SUBJECT: DRAFT Hillsborough SE County Landfill Leachate Evaporator Review

Subject: Hillsborough Southeast County Landfill (SCLF)
Heartland Leachate Evaporator Pilot Project
PES File #20181228

Figure 2 – Process Diagram

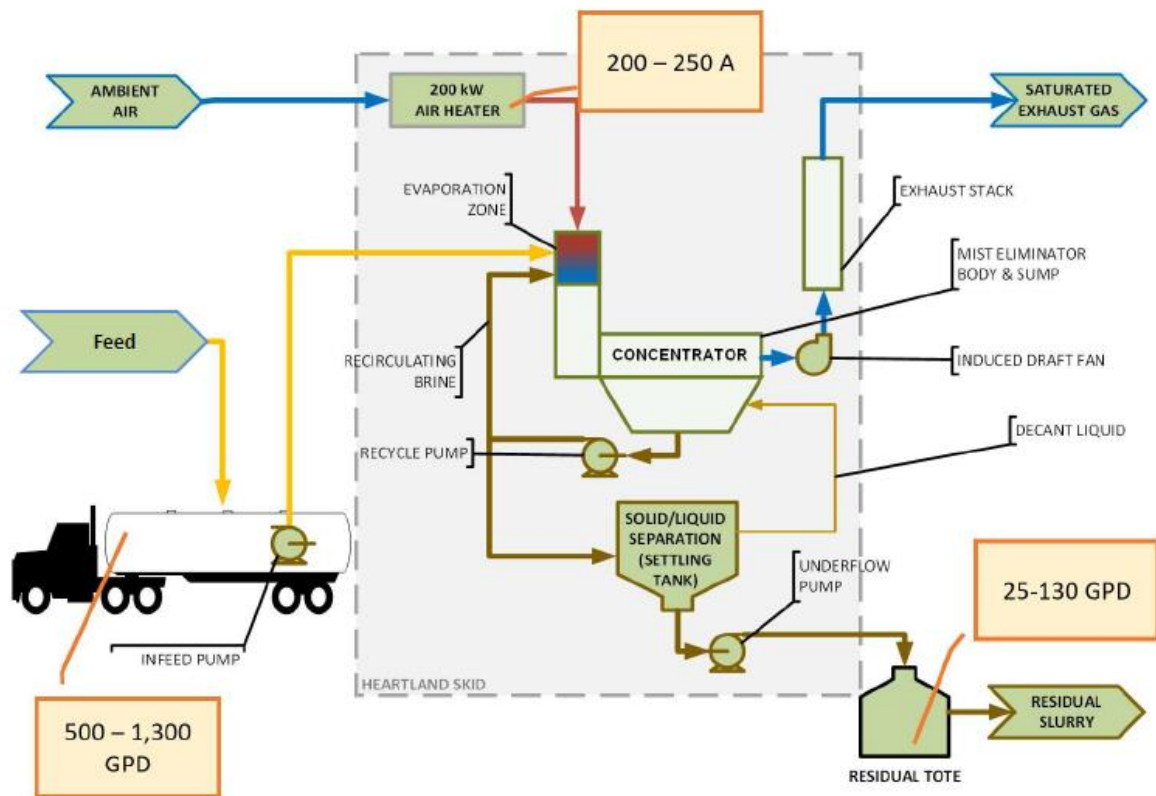
- a. What is the quality of the Saturated Exhaust Gas?
 - i. In the proposed full-scale system, the existing open flare would be replaced with an enclosed flare, and the exhaust gas from the enclosed flare would be used as the heat source for the Evaporator. Under this condition, any constituents not fully combusted by the flare would be introduced into the Heartland system and could be concentrated into the residual slurry (water soluble constituents) or discharged through the Exhaust Stack. It is not known if these constituents could concentrate in the air exhaust stream prior to discharging.

- ii. Heartland indicated that since there is no combustion in the system, the Saturated Exhaust Gas is only water vapor. However, since the Saturated Exhaust Gas contains water vapor, water-soluble leachate constituents will likely be present in the Exhaust Gas. Although combustion by-products (e.g., NO_x, SO_x, CO) are not anticipated, water-insoluble, volatile constituents (e.g., VOCs, ammonia, etc.) that are present in the leachate will also likely be present in the Exhaust Gas.
